# UNITED STATES PATENT AND TRADEMARK OFFICE

APPLICATION NO.	FILING DATE	FIRST NAMED INVENTOR	ATTORNEY DOCKET NO.	CONFIRMATION NO.
10/706,392	11/12/2003	Kuniya Maruyama	MAKU 8814US	6840
1688	7590	08/24/2006	EXAMINER	
POLSTER, LIEDER, WOODRUFF & LUCCHESI 12412 POWERSCOURT DRIVE SUITE 200 ST. LOUIS, MO 63131-3615			REESE, DAVID C	
			ART UNIT	PAPER NUMBER
			3677	
DATE MAILED: 08/24/2006

<b>Office Action Summary</b>	<b>Application No.</b> 10/706,392	<b>Applicant(s)</b> MARUYAMA, KUNIYA	
	<b>Examiner</b> David C. Reese	<b>Art Unit</b> 3677

### **DETAILED ACTION**

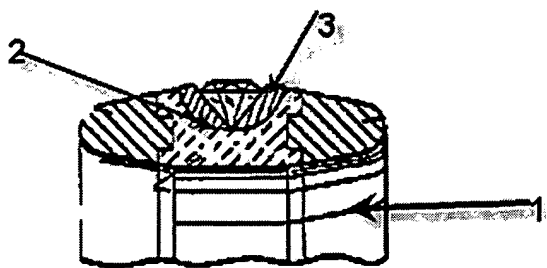
As for Claim 1, West teaches of an item of jewelry (see figure below) comprising a main body (1) having an inlay area (2) formed in said body (1), and a decorating part (3) secured in said inlay area (2); wherein the improvement comprises said decorating part (3) being composed

of precious metal components (col. 6, lines 28, and from Claim 1, “a precious metal disposed within said groove”), [which naturally and uniformly changes color from a copper color to chocolate brown through oxidation and which can be polished back to recover the original color]; said decorating part (3) being secured in said inlay area (2) by a layer of solder (col. 6, line 30, “One way to affix precious metal to the part is to use a brazing process...”) in said inlay area (2) between said decorative part (3) and said main body (1).

The difference between the claim and West is that West does not expressly state that the composition of the decorative part (3) secured in the inlay area (2) of the main body (1) consists essentially of 6 to 15% copper and 94 to 85% gold. First, with regard to the applicant’s use of the terminology “consisting essentially of,” such statement has been recognized by the examiner, and as for the purposes of searching for and applying prior art under 35 U.S.C. 102 and 103,

As for Claim 8, West teaches of an item of jewelry (see figure above) comprising a main body (1) having an inlay area (2) of concaved shape and a decorating part (3) secured in said inlay area (2); said inlay area (2) comprising a main channel (1/2) and at least one groove extending from a side of said channel (1/2); said decorating part (3) being comprised of a copper/gold alloy which contains 6 to 15 percent copper and 94 to 85 percent gold (see above remarks from claim 1) alloy [that naturally and uniformly changes color from a copper color to chocolate brown through oxidation, which can be polished back to recover the original color of the alloy], and which consists essentially of (see remarks from claim 1); said decorative part (3) being secured in said inlay area (2) said decorating part (3) corresponding in shape to the shape

of the inlay area (2) main channel (1/2); said decorating part (3) being deformable to fill said at least one groove upon the application of pressure to said decorating part (3).
